Re: Proposed Tilden Commons Project – July 2026 Submission

As you know, our firm represents Tilden Project LLC, and its partner Hudson River Housing, Inc. (Applicant), with its efforts to develop the Tilden Commons (Project) at 538 Route 20 New Lebanon, New York 12125 (Tax Map ID 19.2-1-69) in the Town of New Lebanon, New York.

- Exhibit A: Revised Legal Justification Letter, dated July 2, 2025, revised July 1, 2026.
- Exhibit B: Responses to Town Designated Engineer's Comments, dated July 1, 2026. The comments of the Town Designated Engineer from his letter dated May 20, 2026 are included and the Applicant's responses are in **BOLD** below each comment.
- Exhibit C: Updated Civil Site Plan Set, dated July 1, 2026.
- Exhibit D: Stormwater Pollution Prevention Plan (SWPPP), dated April 1, 2026, and the Post-Construction Stormwater Management Plan.

LANDSCAPE PLAN

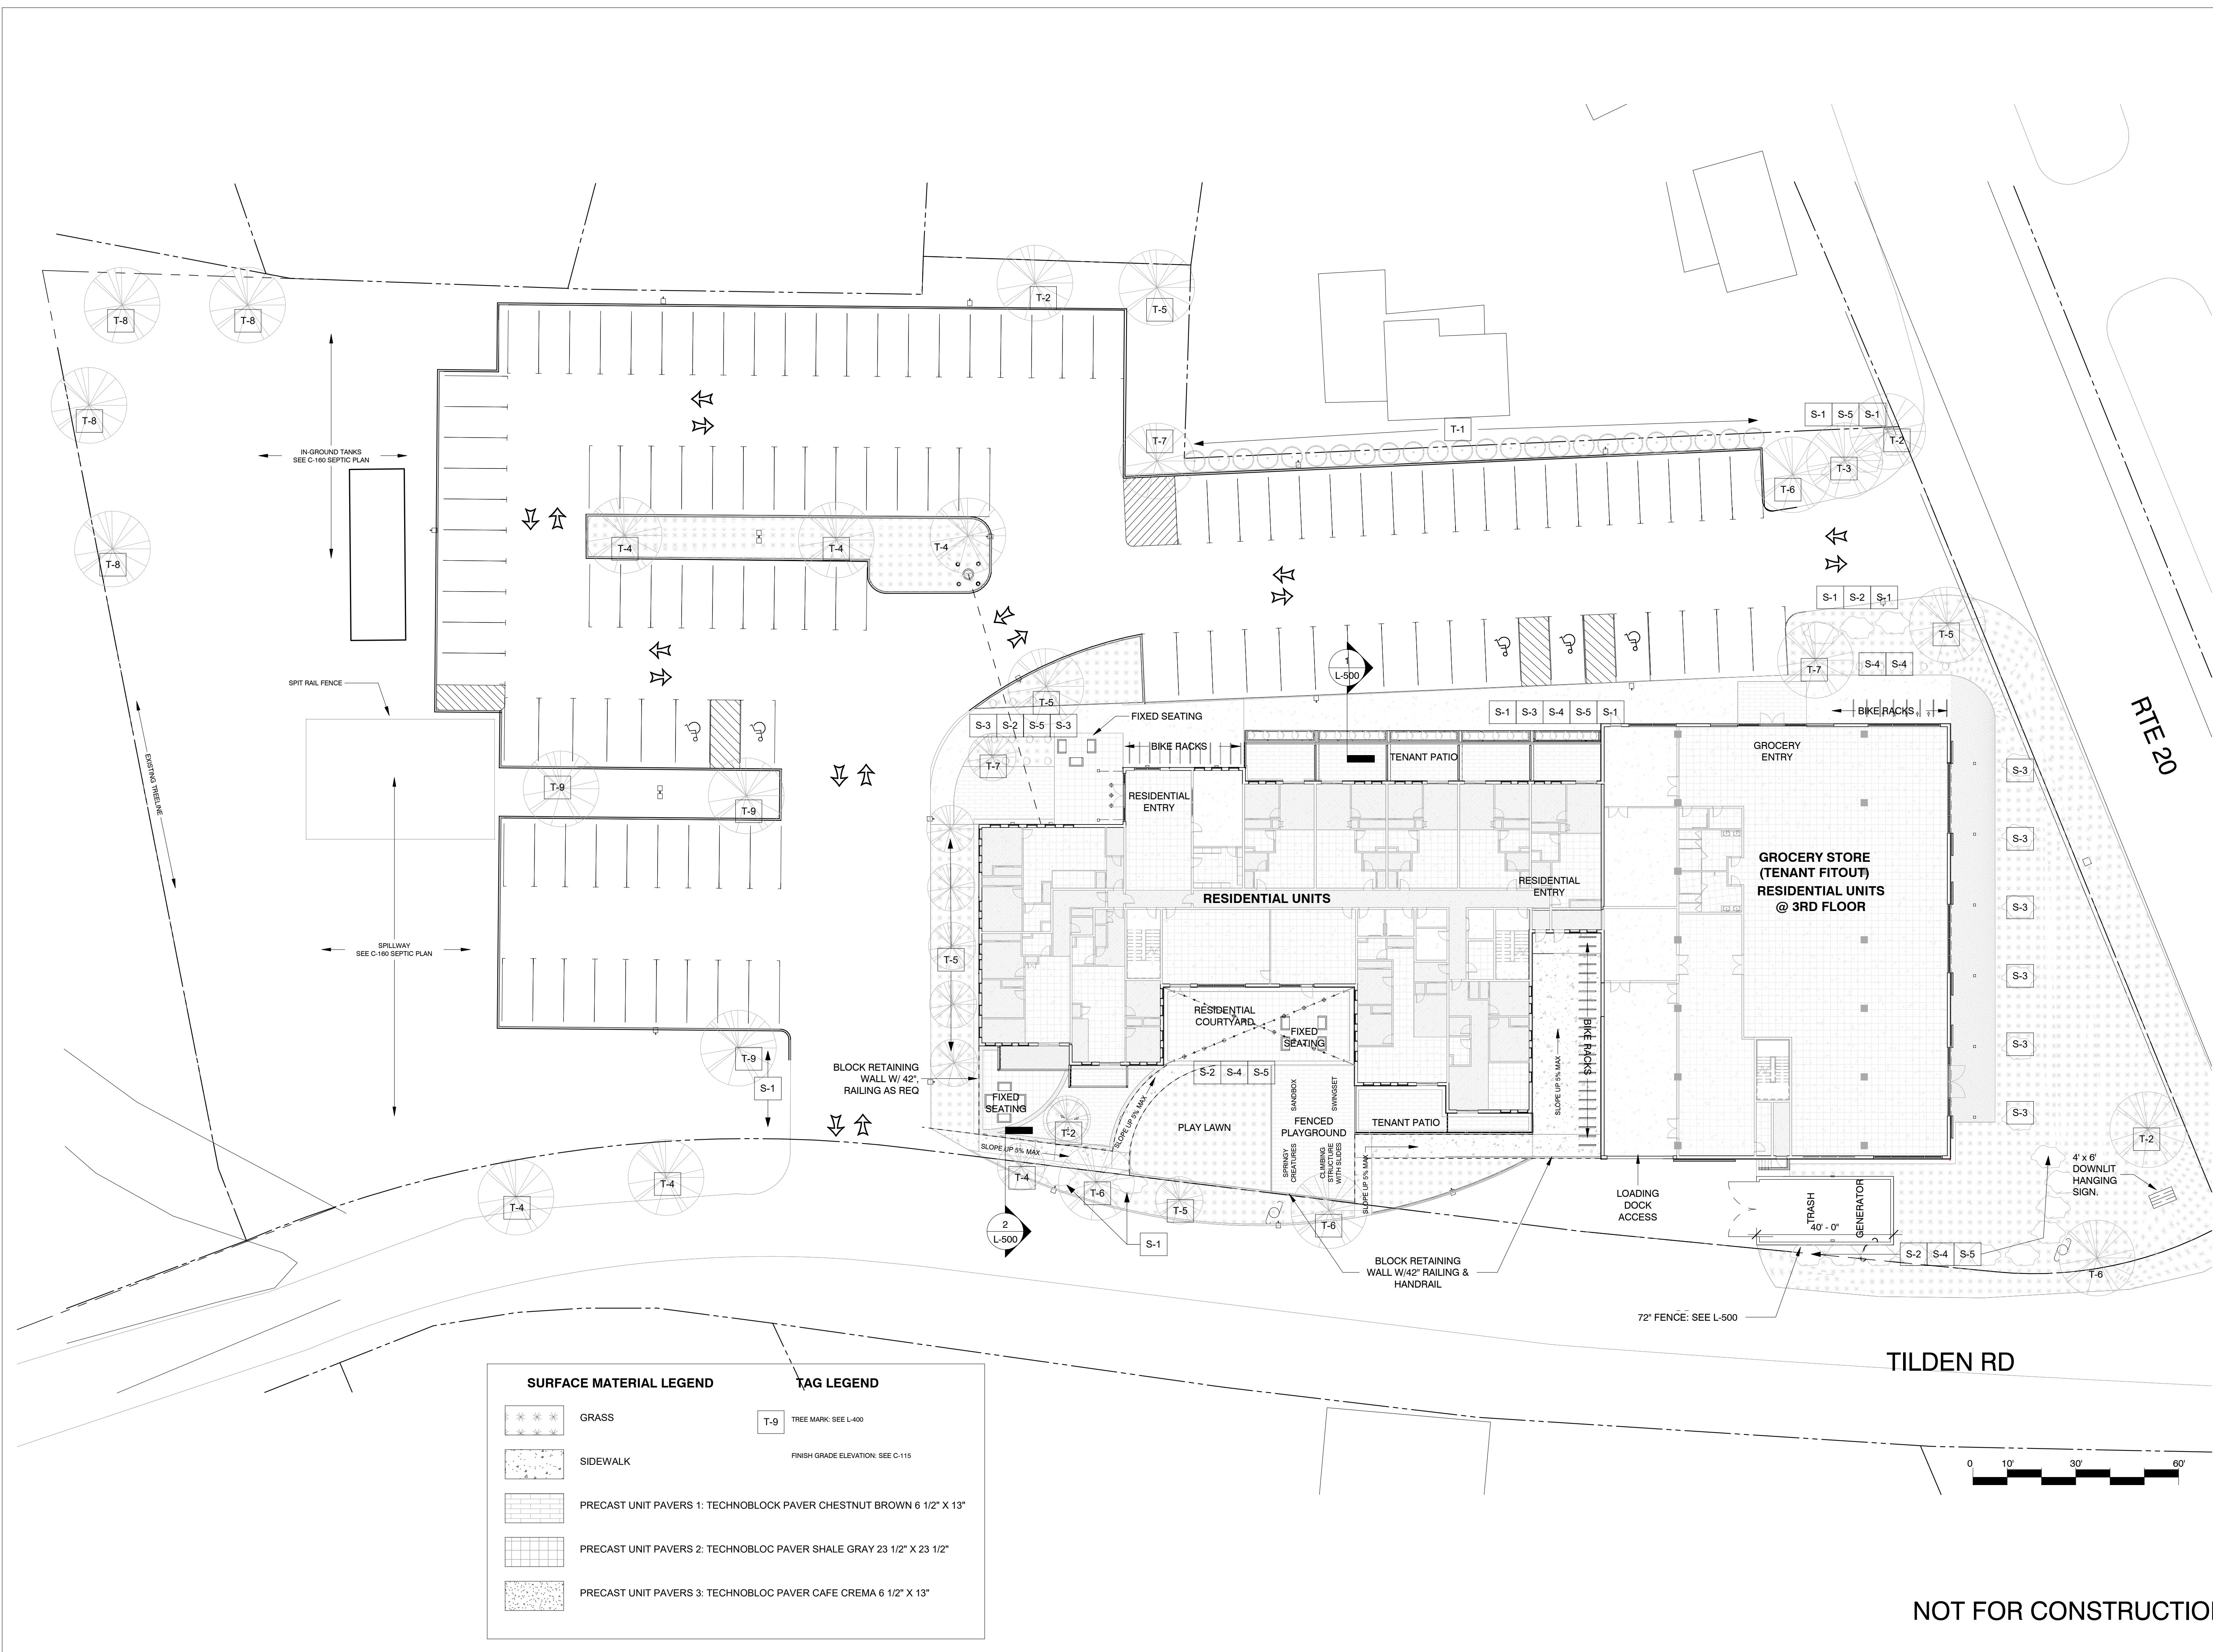
Exhibit C (Sheet L-100 – LANDSCAPE PLAN)

Sheet C130 – NYSDOT ENTRANCE & GENERAL PLAN

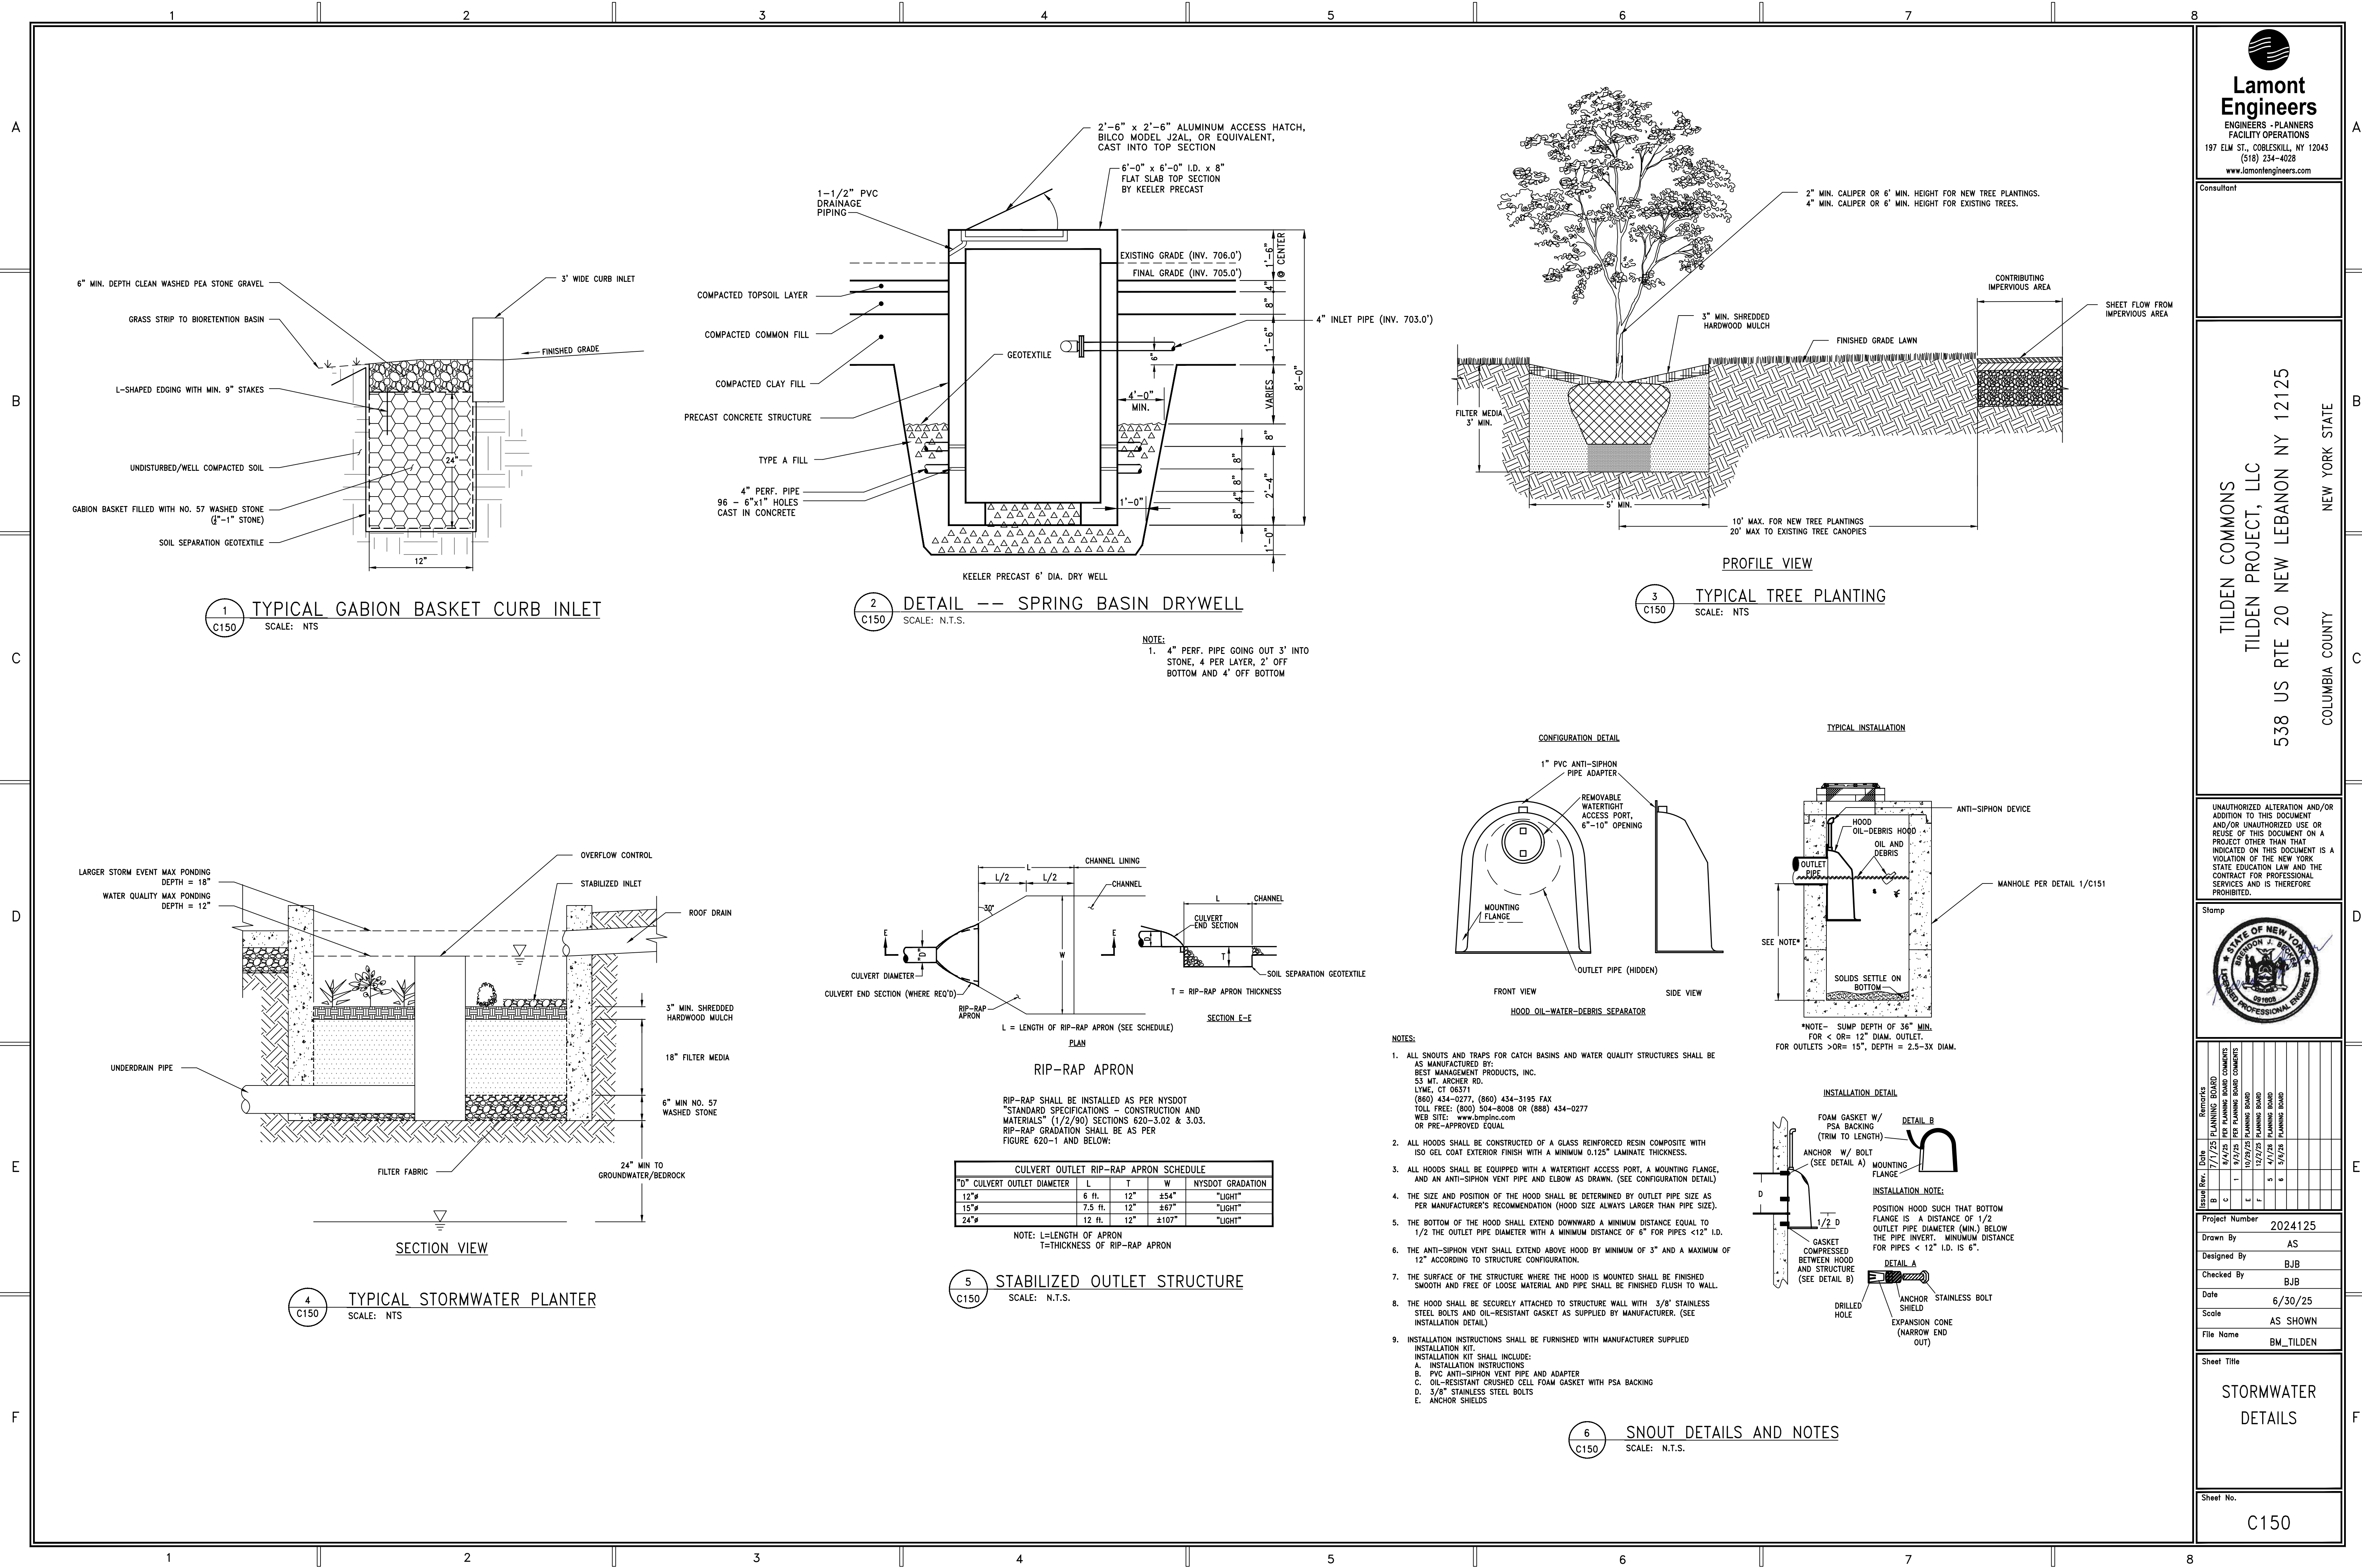
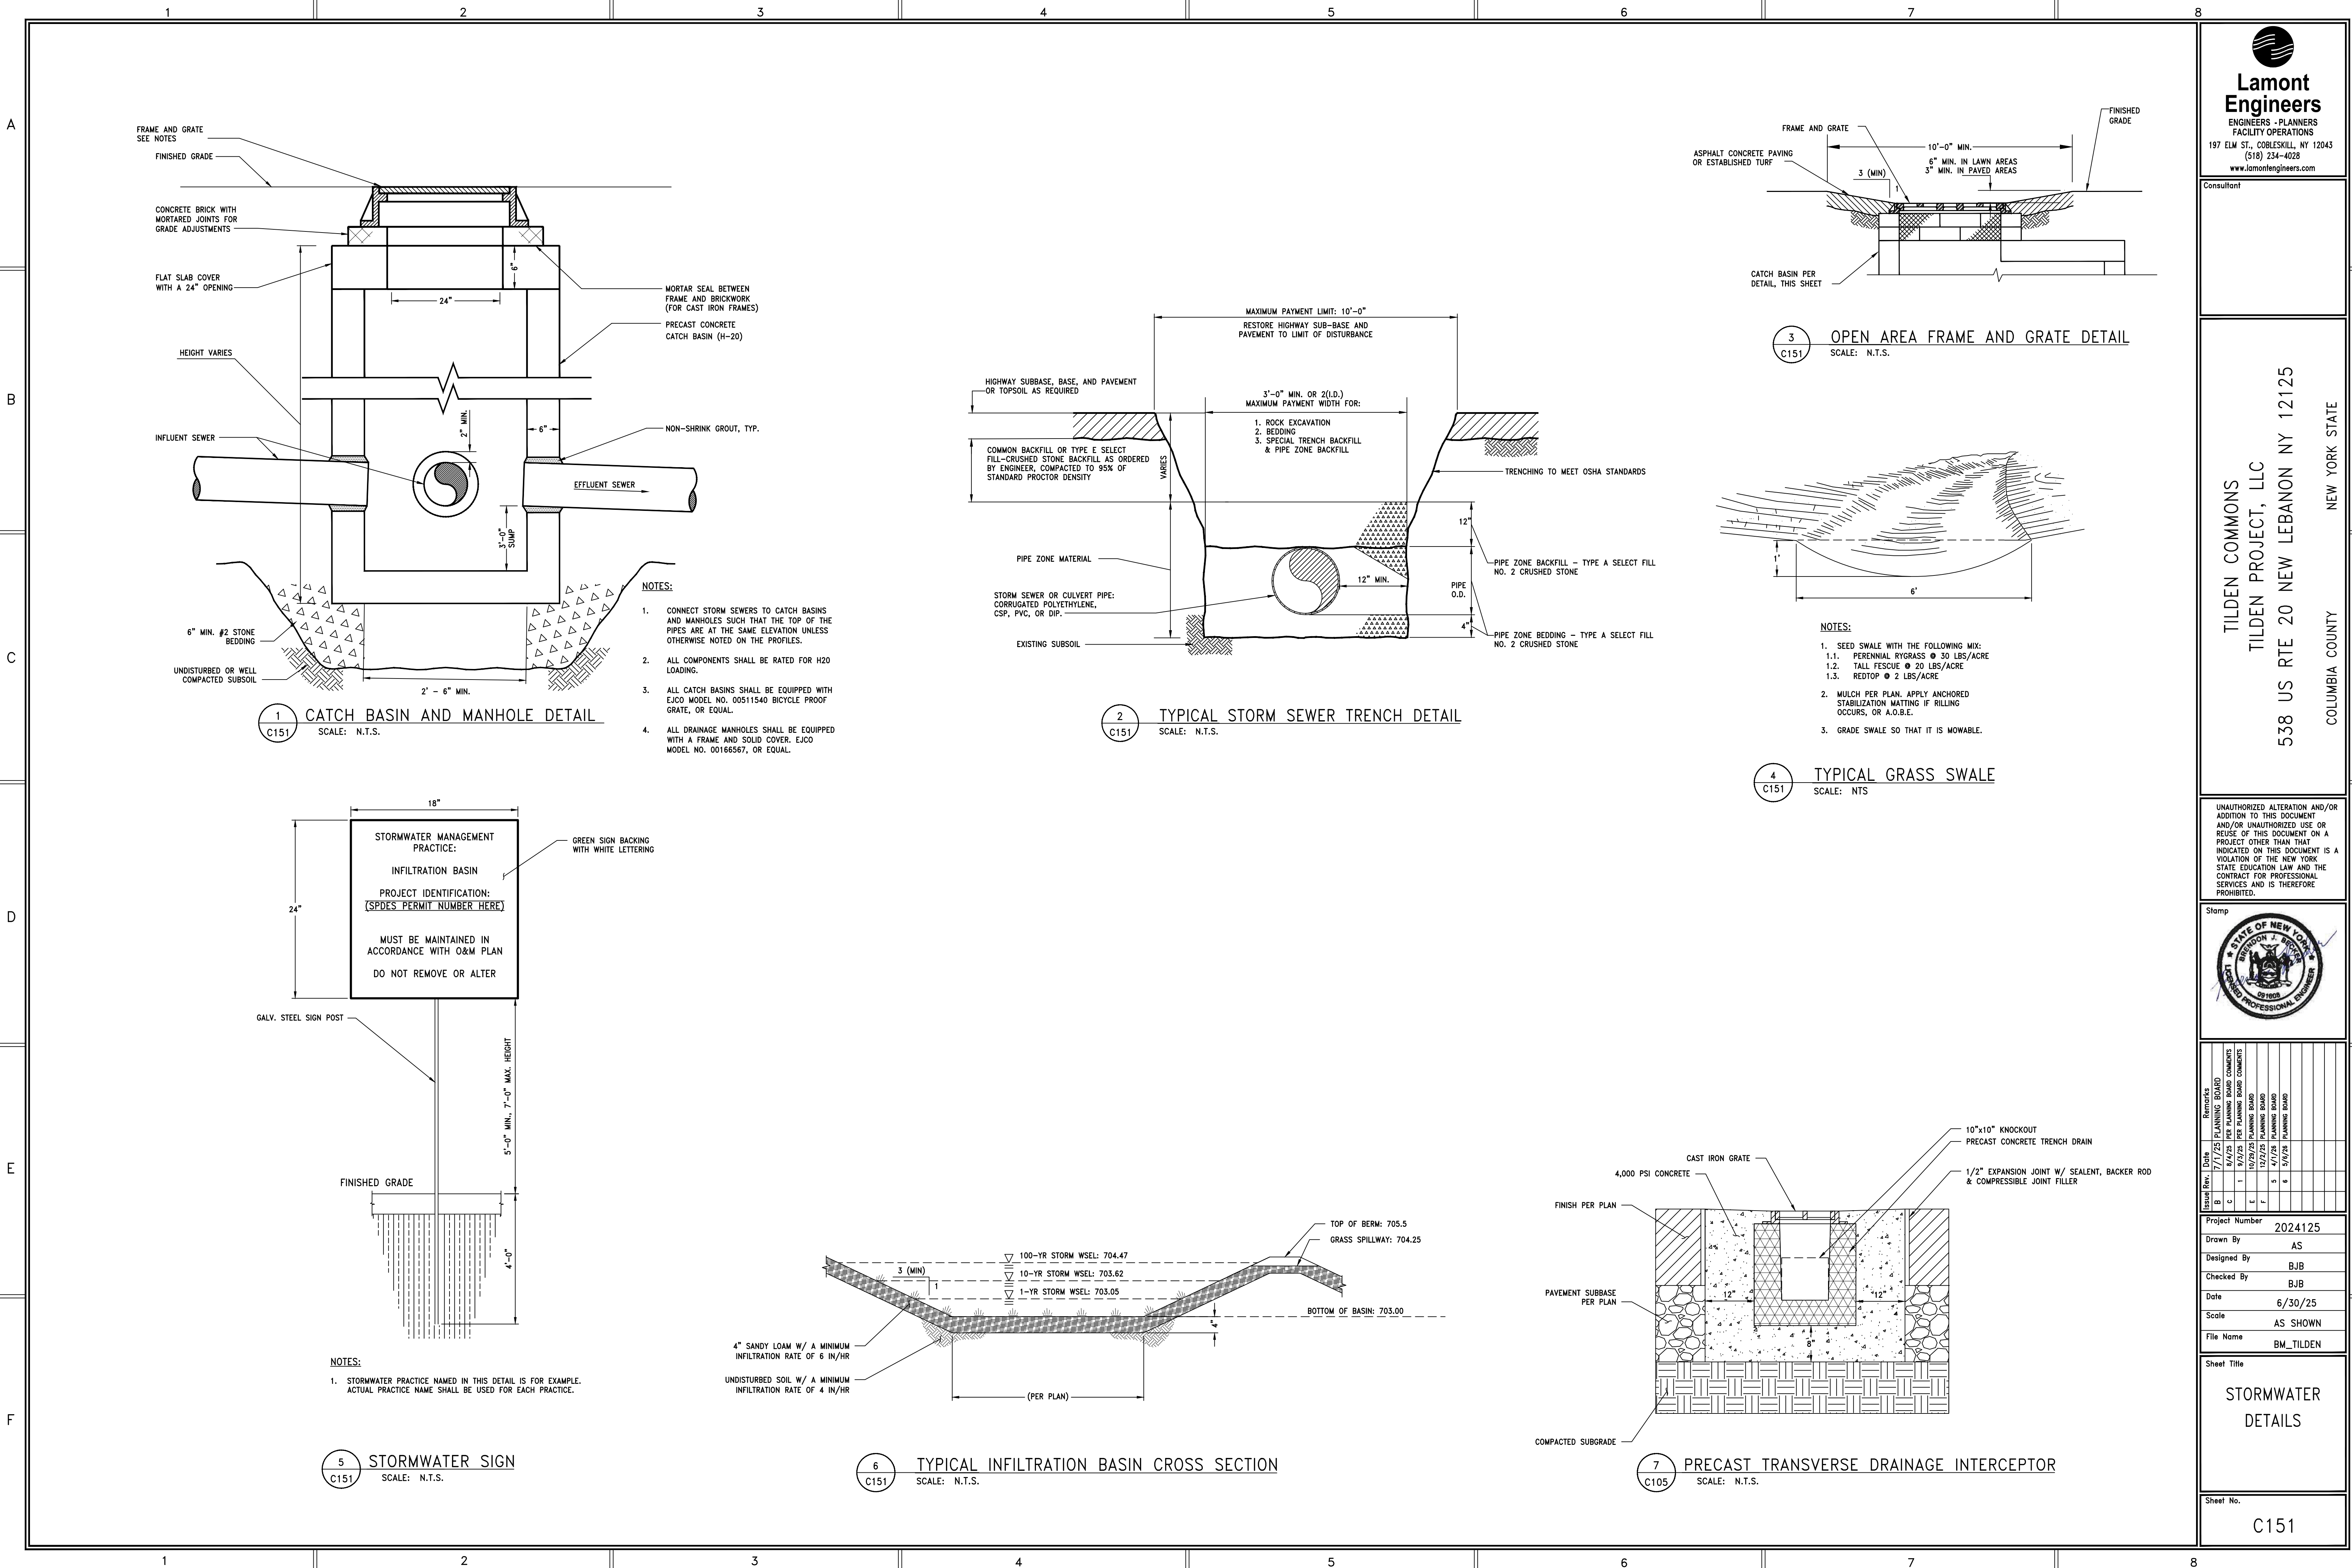
1. *Sheets C130–C131 depict the proposed site access connection to NYS Route 20. Review and approval of driveway location, geometry, grading, drainage, and construction within the State highway right-of-way are subject to final review and approval by the New York State Department of Transportation (NYSDOT) and issuance of a Highway Work Permit. No work within the NYS Route 20 right-of-way may occur without NYSDOT approval.*
 - Show the sawcut line on the plan, add a callout stating "proposed pavement shall meet existing line and grade", provide spot grades at the tie in corners, label the radii, show the demo of the existing curb, etc. **Notes have been added.**
